NUCLEAR REGULATORY COMMISSION

Title: Advisory Committee on Reactor Safeguards
APR1400 Subcommittee

Date: May 18, 2017

Chapter 9: Auxiliary Systems

9.1.1 Criticality Safety of New and Spent Fuel Storage

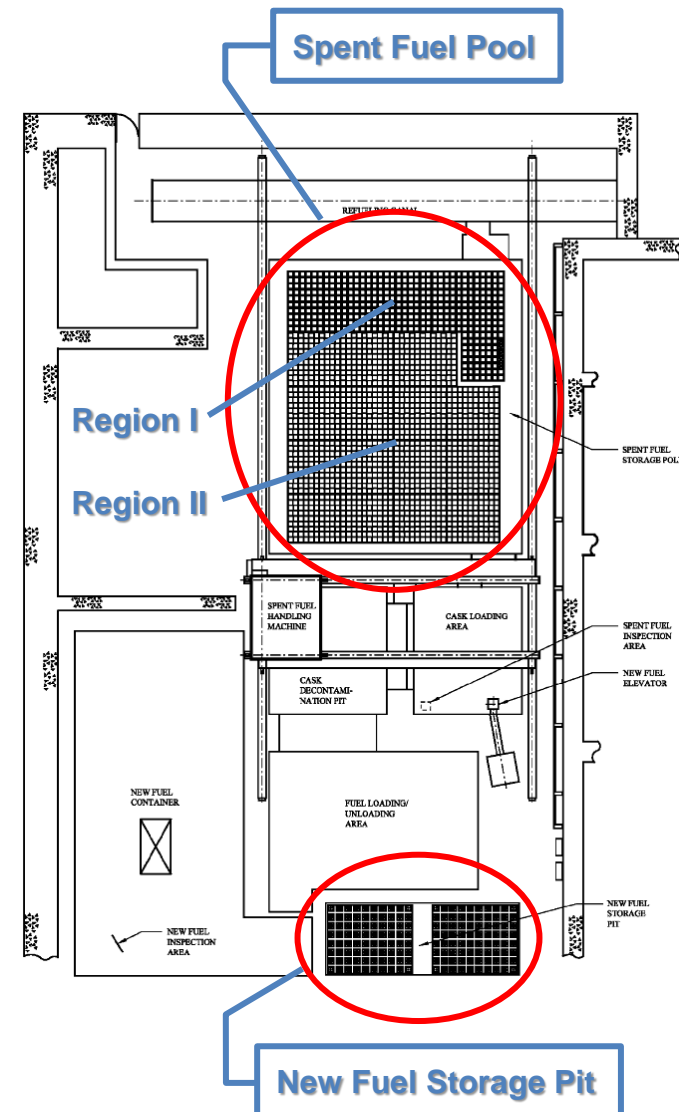
15 MEMBER SKILLMAN: I would like to ask this
16 question. Let me divert your attention back to Slide
17 6, please.

6 MEMBER SKILLMAN: Let me ask this
7 question. On this image on Slide 6, you show the spent
8 fuel racks.

10 MEMBER SKILLMAN: On your Slide 14, at
11 your second bullet, you communicate that you will -- let
12 me see what I'm looking at. The intent is to make sure
13 that the fuel assemblies are not injured, mechanically
14 not injured. My question is what consideration have
15 you given to a coal item for rack alignment?

23 If the racks are not aligned at original
24 construction, you have the capability of raking your
25 fuel assemblies and damaging them. My question is have

8 MEMBER SKILLMAN: Thank you. I've made
9 my point. What I wanted to really communicate is
10 unless there is a precise alignment for bridge and
11 trolley in the location of the cells, you have the great
12 opportunity to rake the spacer grids and do damage. If
13 you have a thrice-burned assembly that is bowed, and
14 that assembly doesn't really want to go into that cell,
15 you can end up destroying the fuel assembly in the cell.
16 If you are very precise about your rack alignment at
17 construction, you may save yourself great effort as the
18 plant lives. Thank you.

10 The first time, maybe, the machine go into
11 the designated locations, but if the rack accidentally
12 misaligned and not placed in a correct position, when
13 the machine load the fuel into the rack, maybe there's
14 contact happen, yes. In that case, the motion catch
15 the load tangent from the load cell, and also, operator
16 watch the train level (phonetic) load transition. If
17 the load is changed (unintelligible) level, the machine
18 automatically stops loading. Another system is
19 supported to safe operation is the camera system.
20 Operator simultaneously watch the loading condition
21 and the rack location with the camera. This is some
22 safety function for the fuel handling light load
23 handling system.

1 fuel handling machine, we also have some call action
2 items for periodic inspection program of spent fuel
3 lack integrity to ensure that the design basis material
4 and geometric assumption remain valid during the
5 operating life of plant. That can also give you some
6 credit to the right place for that spent fuel pool in
7 a spent fuel pool lab.

10 MS. BURJA: This is Alex Burja, from the
11 staff. I just wanted to add, on the rack alignment
12 question, there's an ITAAC to verify the layouts.

9.2.1 Essential Service Water System (ESWS)

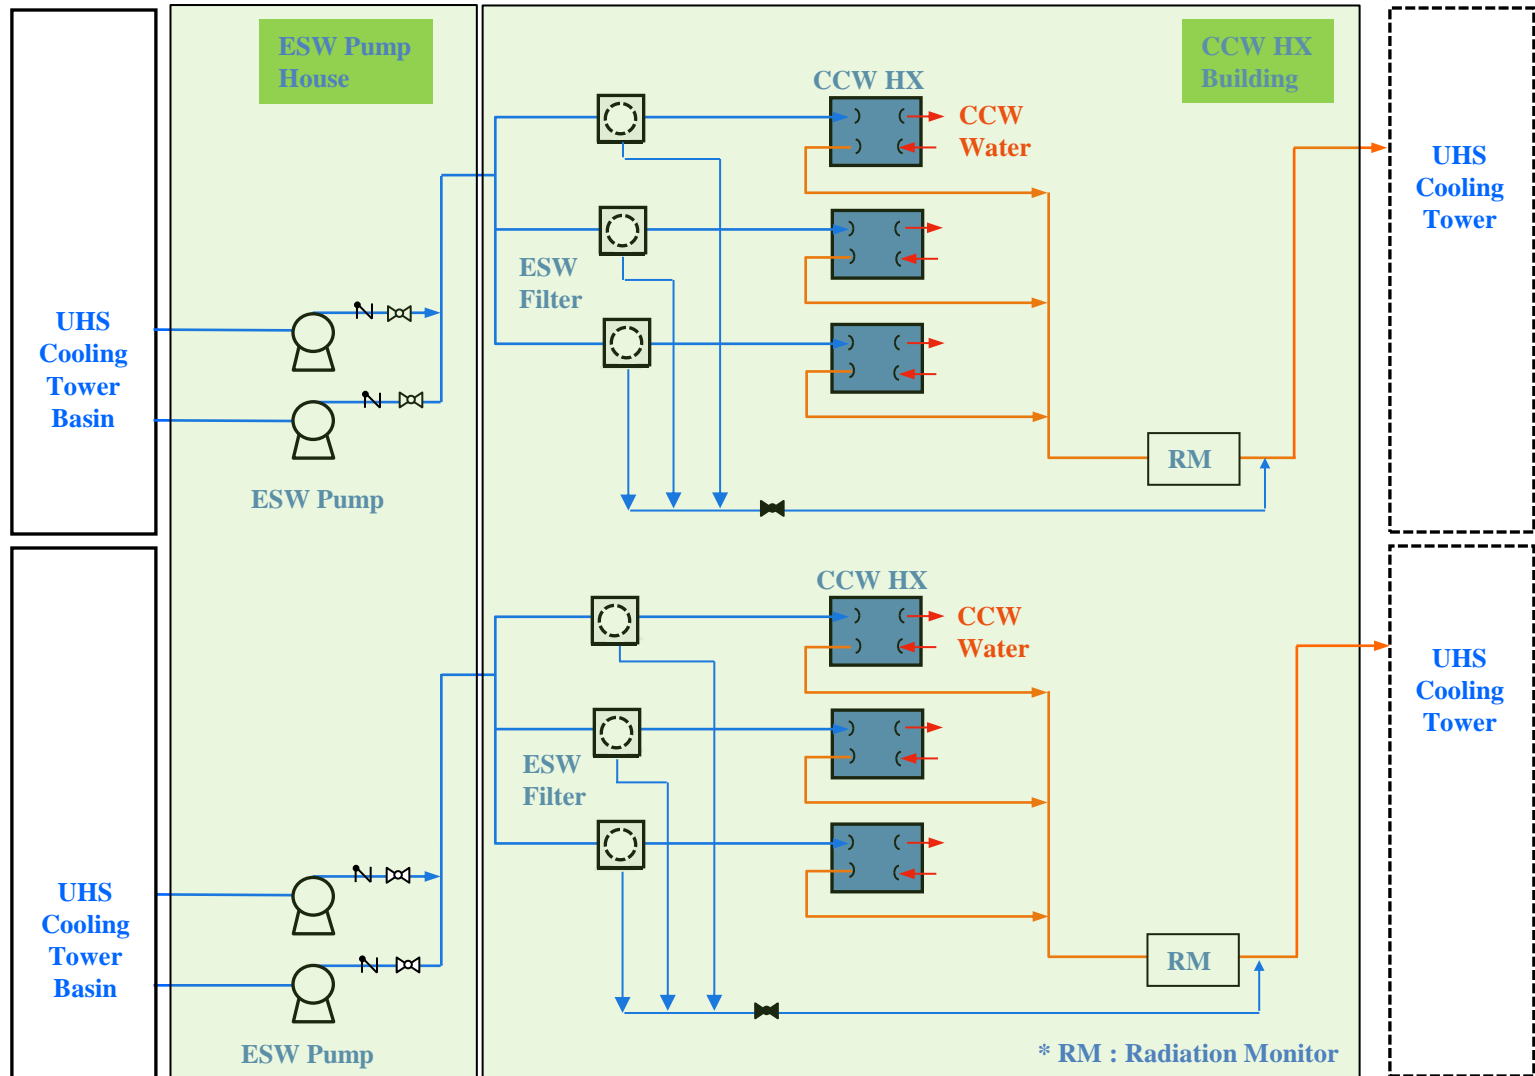
22 MEMBER SUNSERI: I had a question about
23 that. When I look at your detailed drawing -- I know
24 you've got a simplified drawing on the next page -- in
25 the text of the DCD, it describes the flow path for the

5 It has to go up, and then come back down.
6 I'm suspecting that the high point is going to be
7 somewhere near the component water heat exchanger. So
8 it's going to come up to the component heat exchanger.
9 In fact, the drawing says that there's high point vents
10 at the highest elevation, around there. That's the
11 setup for my question. My question is you say your
12 design for water hammer, you've taken the water hammer
13 considerations from the NUREG-0927. I think this
14 design appears to me to be vulnerable to column
15 separation because in the event of a loss of offsite
16 power, the pumps are going to stop. The water on the
17 down leg side of the heat exchanger is going to start
18 draining to the ultimate heat sink.

1 I guess it appears that there's nothing in
2 the design that accounts for that because NUREG-0927
3 talks about keep-full systems and backing breakers and
4 such, but I see it looks like this application is
5 passing all of that off to the COL applicant to design
6 the water hammer system. Can you comment on this?

19 MEMBER SUNSERI: I hear you talking about
20 a vacuum breaker. Can you tell me where this vacuum
21 breaker is on this drawing?

7 MEMBER SUNSERI: Is that the component
8 that's labeled TEWO-052? I don't see a vacuum breaker
9 on this drawing.

22 MR. Y. KIM: This is just the schematic
23 drawing, so I didn't put the details.

3 MR. Y. KIM: DCD Figure 9.2.1-1, there is
4 the systems currently -- the flow diagram. There is
5 a vacuum breaker in each division, downstream of the
6 CCW exchanger.

22 MR. Y. KIM: In the reference plant for the
23 APR1400, we used sea water as the ultimate heat sink.
24 In that case, we made the vacuum breaker downstream of
25 the CCW exchanger. But in the APR1400 design, we have

9.2.2 Component Cooling Water System (CCWS)

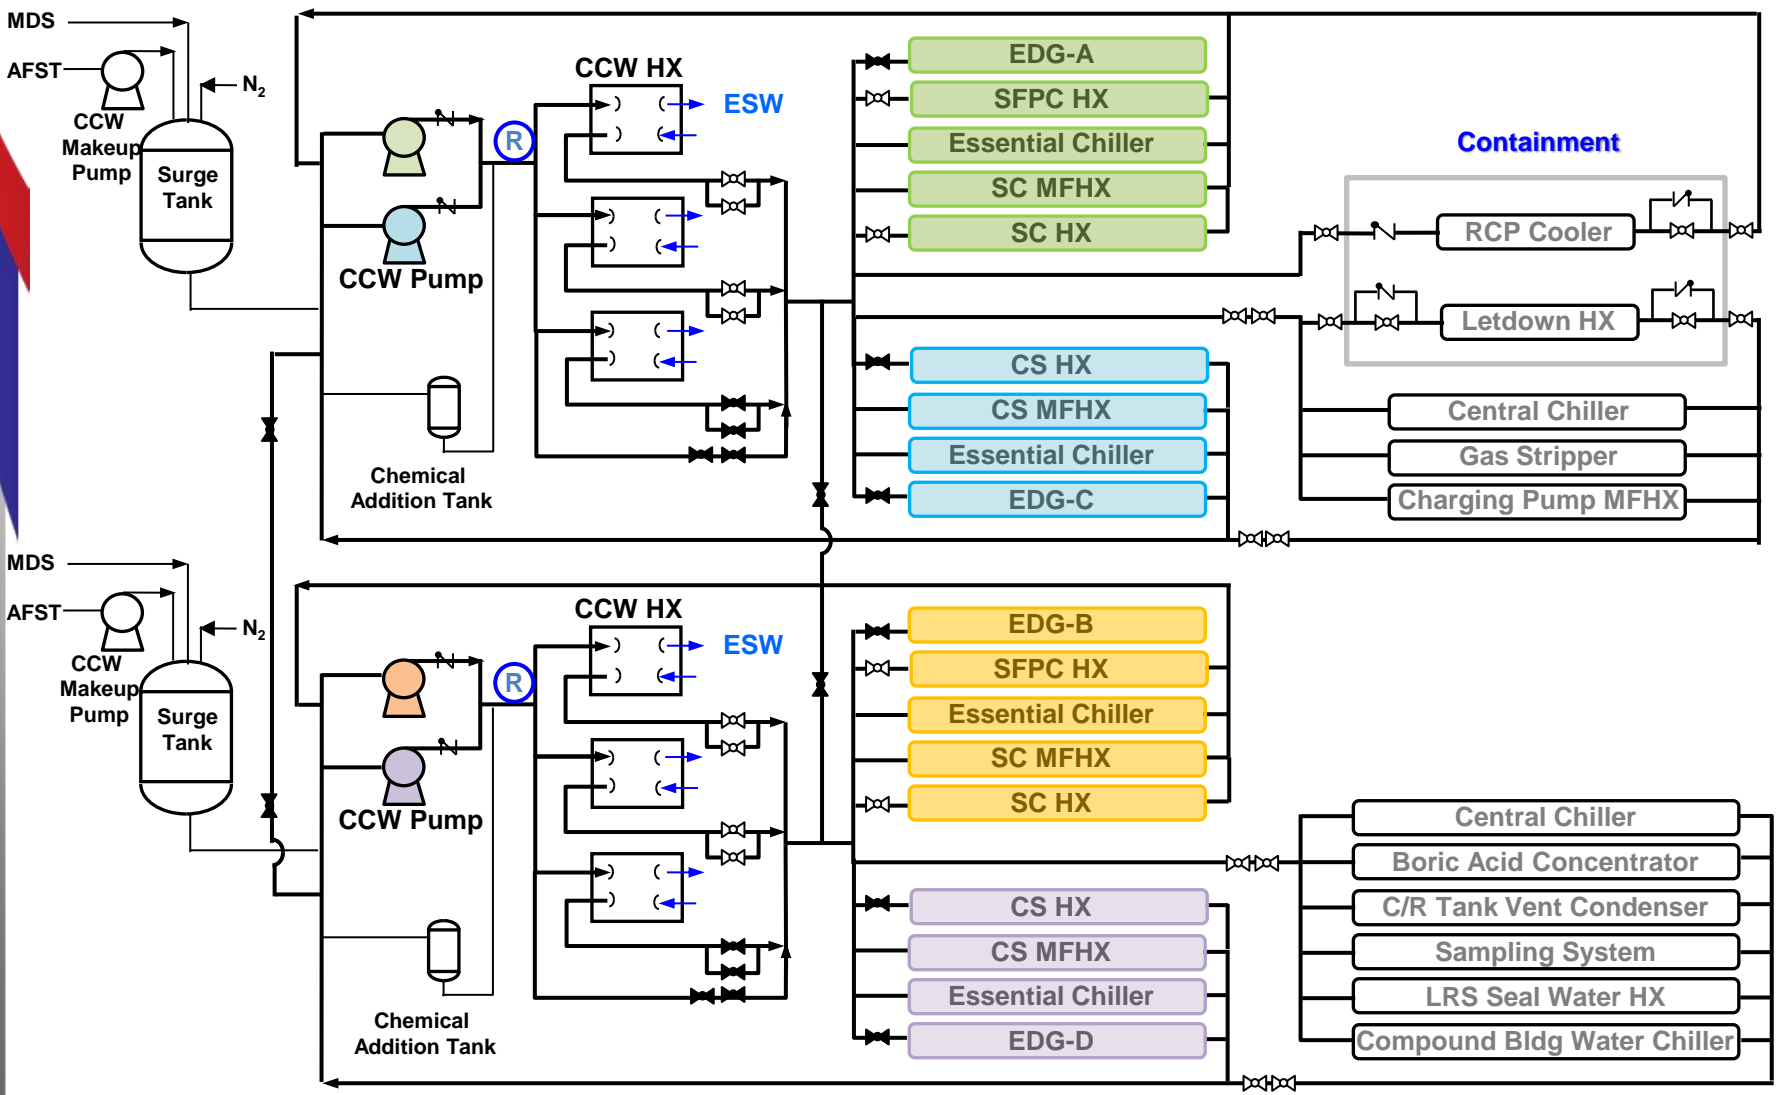
6 MEMBER STETKAR: Mr. Kim, a couple of
7 questions about CCW. CCW supplies cooling to the
8 reactor coolant pump, thermal barrier heat exchangers,
9 the bearing oil coolers, and the motor coolers.

1 MEMBER STETKAR: That's the worst
2 condition, in terms of the time. I do have one
3 question, though, that I hope I can get answered. In
4 the DCD -- if you want the section numbers, I can give
5 them to you, but let me just ask the general question.
6 I know during normal operation, you have one component
7 cooling water pump running in each division and one ESW
8 pump running in each division. You need that. In the
9 DCD, it says that, for example, in Section 9.2, four
10 component cooling water pumps and six component cooling
11 water heat exchangers in both divisions are required
12 to accomplish a normal shutdown. That says that when
13 I shut down the plant for refueling outage, you
14 typically start all of the ESW pumps and all of the
15 component cooling water pumps. First of all, is that
16 necessary? Second of all, is it the normal practice
17 at the reference plant?

3 MEMBER STETKAR: From power operation
4 through the first part of the outage, through the normal
5 outage, and into startup. This is, again -- I wanted
6 to confirm that the information in the DCD is correct
7 and consistent with actual practice. That's the
8 important thing. If it is, then this is a PRA modeling
9 question, it's not a system question. But the PRA
10 model should be consistent with how the system is
11 actually operated.

1 MR. OH: This is Andy Oh, KHNP Washington
2 Office. For the answer for the first question, there's
3 no automatic trip signal for when the loss of CCW case
4 for the RCP. Second is that can be taken care of based
5 on normal operations procedure? There's two cases,
6 loss of CCW only and loss of CCW and loss of injection
7 water, so ceiling water. In the first case, when loss
8 of CCW, we have ten minutes available time for operator
9 to manually shut down RCP.

17 MR. OH: Based on it for the reference plan
18 and normal procedure, that procedure that's described
19 that the operator have to do some manual action within
20 ten minutes when the loss of CCW. In case of loss of
21 CCW and seal injection, most cases, operator have to
22 manual trip for RCP within three minutes.

7 MR. OH: Because it's per the APR1400 and
8 combustion engineering plants, even there's a loss of
9 CCW, still, if the seal injection is available, some
10 seal injection water can do the work of the cooling
11 function.
